HILCORP ENERGY COMPANY
JICARILLA A 5
TA or P&A NOI

Re: Permanent Abandonment
Well: Jicarilla A 5 API: 30-039-06419

CONDITIONS OF APPROVAL

JICARILLA A 5 - PROPOSED P&A WELLBORE SCHEMATIC

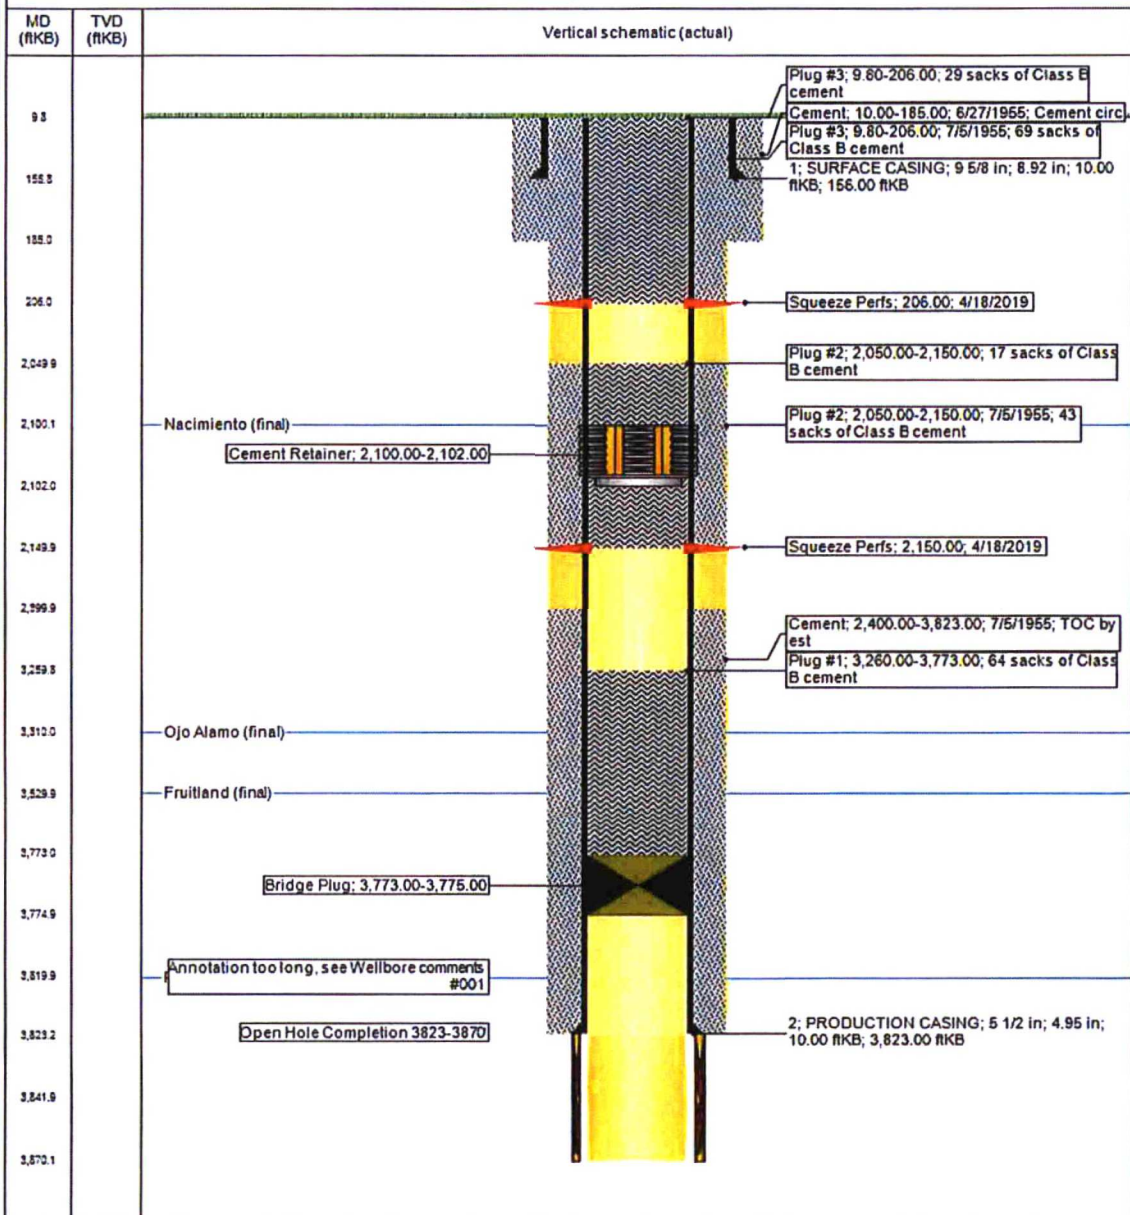
1. Plugging operations authorized are subject to the attached "General Requirements for Permanent Abandonment of Wells on Federal and Indian Lease."
2. Farmington Office is to be notified at least 24 hours before the plugging operations commence (505) 564-7750.
3. Submit electronic copy of the CBL for verification to the following addresses: jkillins@blm.gov , jhoffman@blm.gov and Brandon.Powell@state.nm.us . Based on CBL results inside/outside plugs and volumes will be adjusted accordingly. Please review the General Requirements document to ensure volumes meet required excess inside and outside casing.
4. To plug the open-hole section of the well a cement plug shall be placed to extend at least 50 feet below bottom of casing except as limited by TD or PBTD to 50 feet above casing bottom depth.
